Q3 SCAPULA'S AND HIP CUPS

GRSP IG Child Restraint Systems
April 19, 2016

Drawing updated Scapula

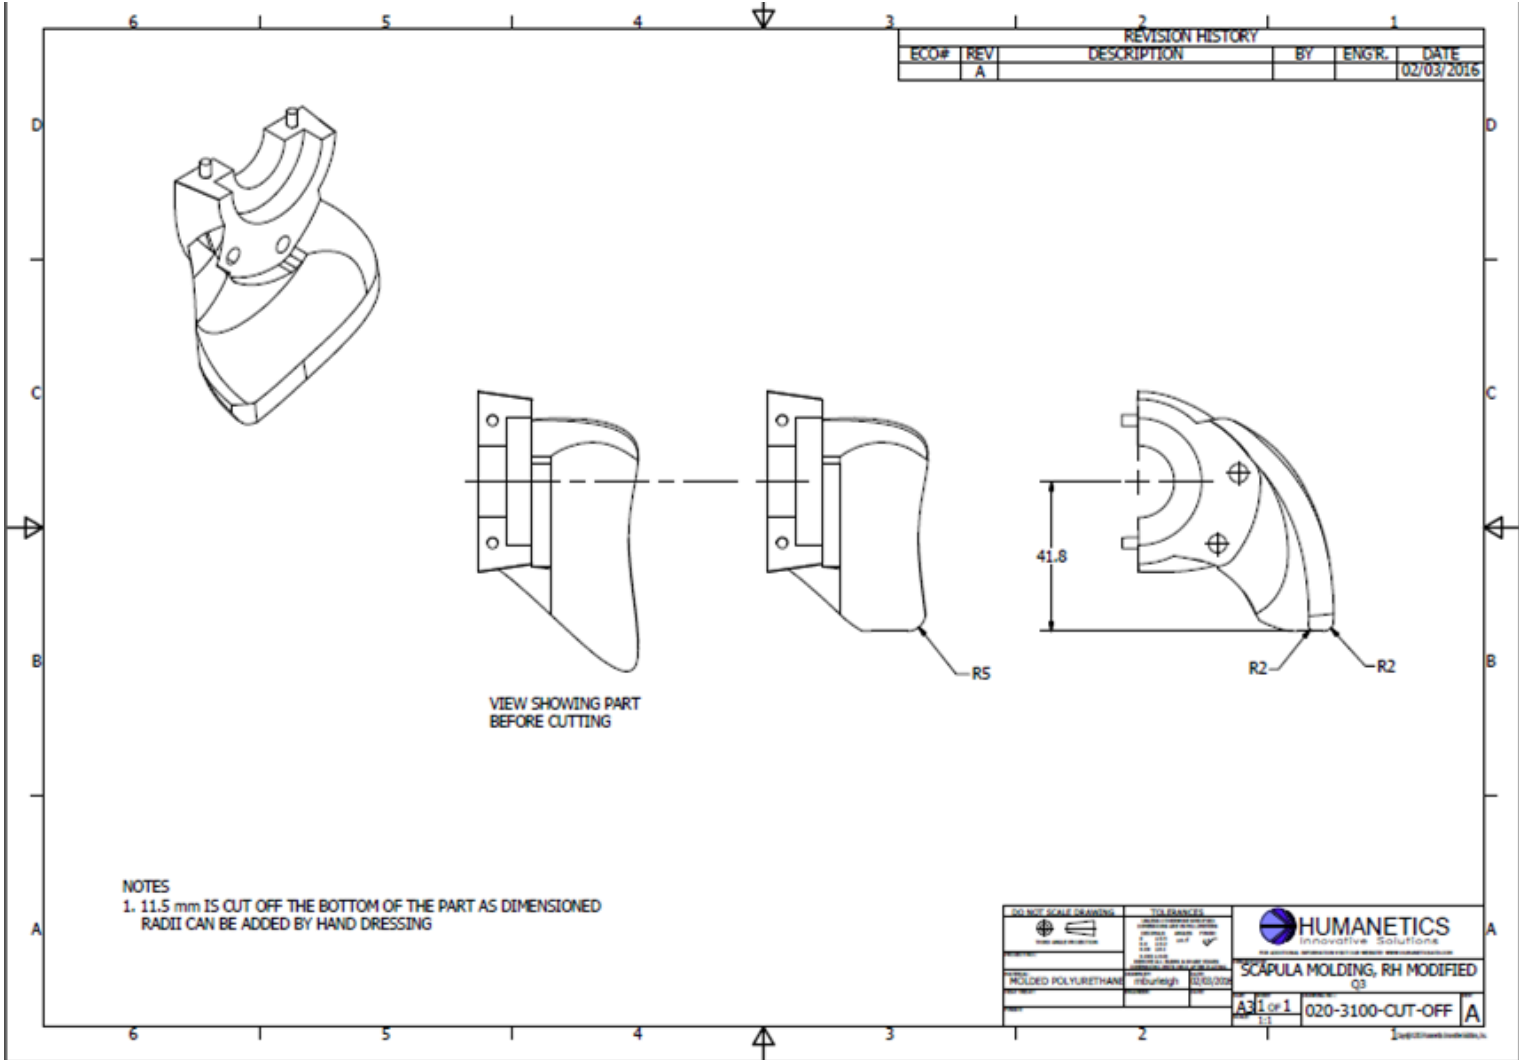
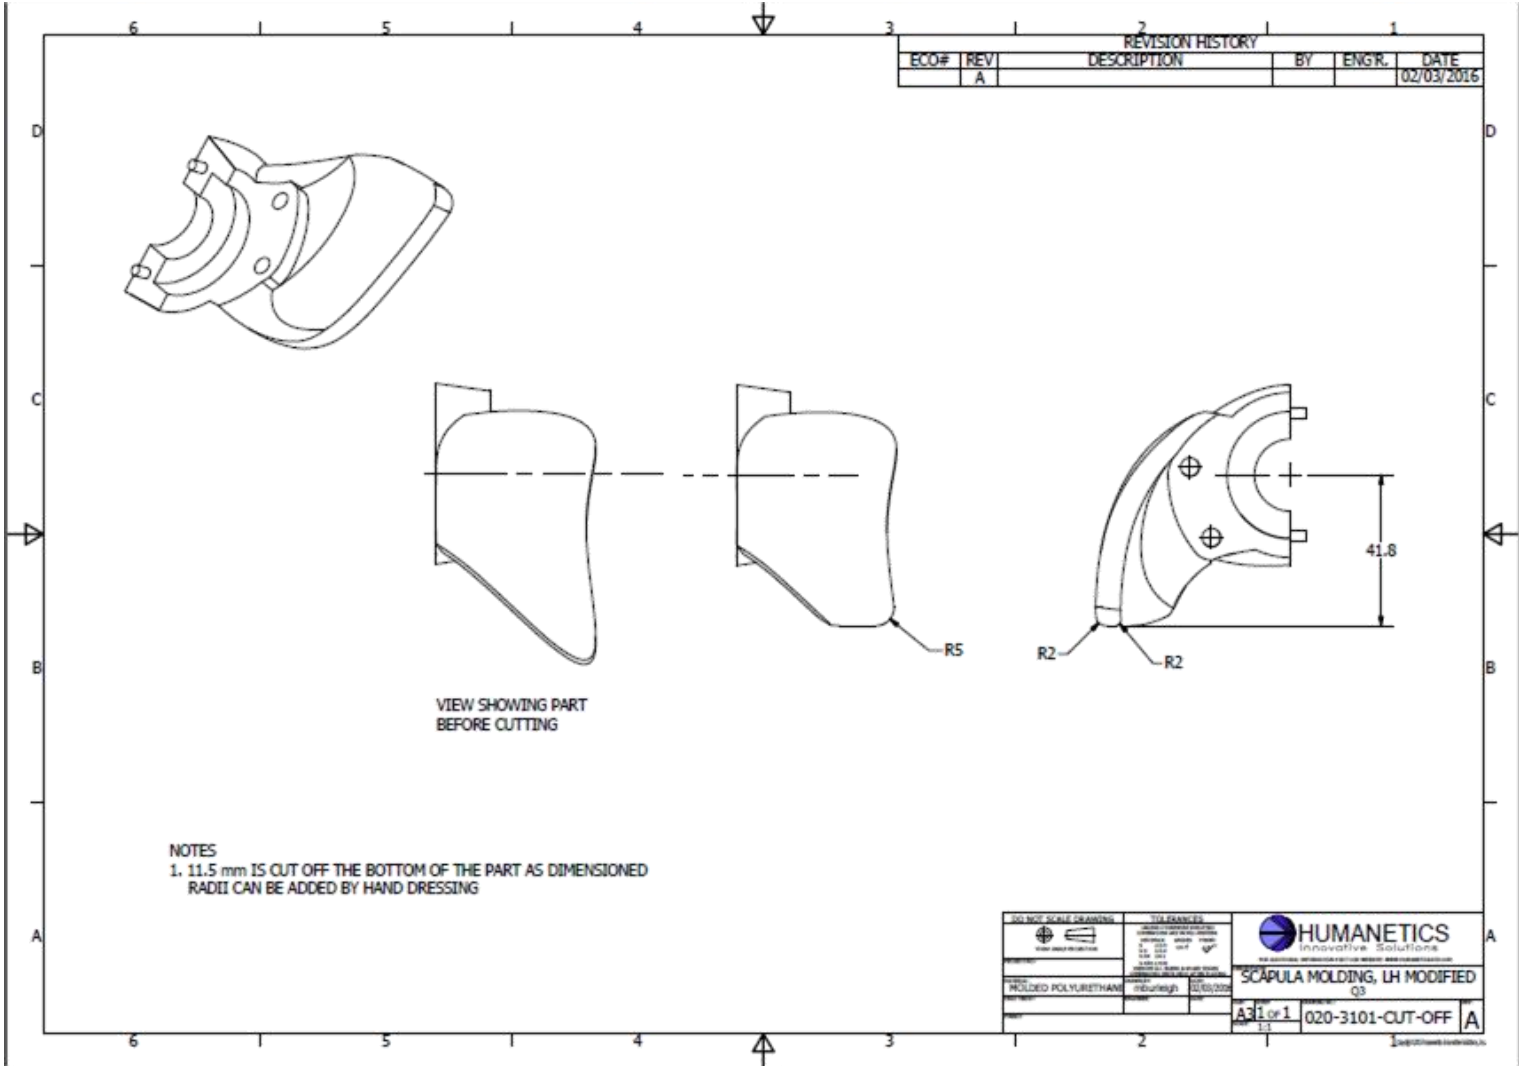
- Various OEMs and test houses report contact interactions between scapula and ribs in Q3 dummy
 - Different from chest chin contact
 - Occurs in full scale vehicle crash tests or equivalent conditions
- It is recommended to take off 11.5 mm from the lower end of the Q3 scapula
 - Existing scapula's can be updated easily by grinding or even with sandpaper

- Currently various changes in lower torso are being introduced to the Q3 dummy
 - Adding APTS sensors
 - Updating abdomen to install APTS
 - Adding hip liners
- Q3 Drawing package related to these changes to be updated by Mid 2016
- Humanetics proposes to include the aluminum hip cups in this update
- Humanetics also proposes to update the Q3 scapula's

Q3
Plastic
hip cups

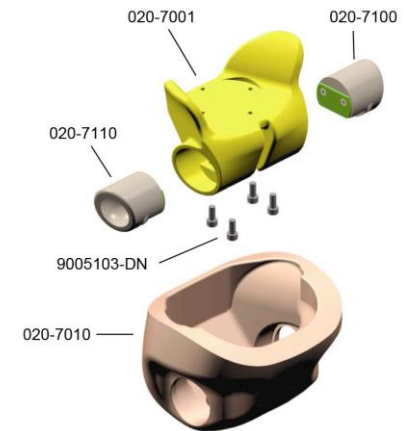
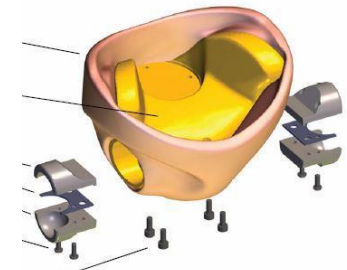
- Original Q dummies design used Ureol (brand name of Poly Urethane systems) plastic type
- This material was banned under REACH
- Alternative material identified and introduced in 2012
 - Thermoset material
 - Similar density and higher strength
 - Less failures on parts like thorax and clavicle reported but
- Issues with hip cups
 - Reports on femur ball releasing from cups (leg separates from dummy)
 - With old Ureol hip cups failures observed after 50+ tests
 - With replacement material failures more frequently observed

- In the field aluminium hip cups from Q6 are being used on the Q3 dummy
- Identical fit but
 - Q3 drawing package specifies plastic material
 - Approximately 20 grams mass difference
- ADAC is currently running Q3 tests using the Aluminum hip cups
 - No issues reported after large number of tests
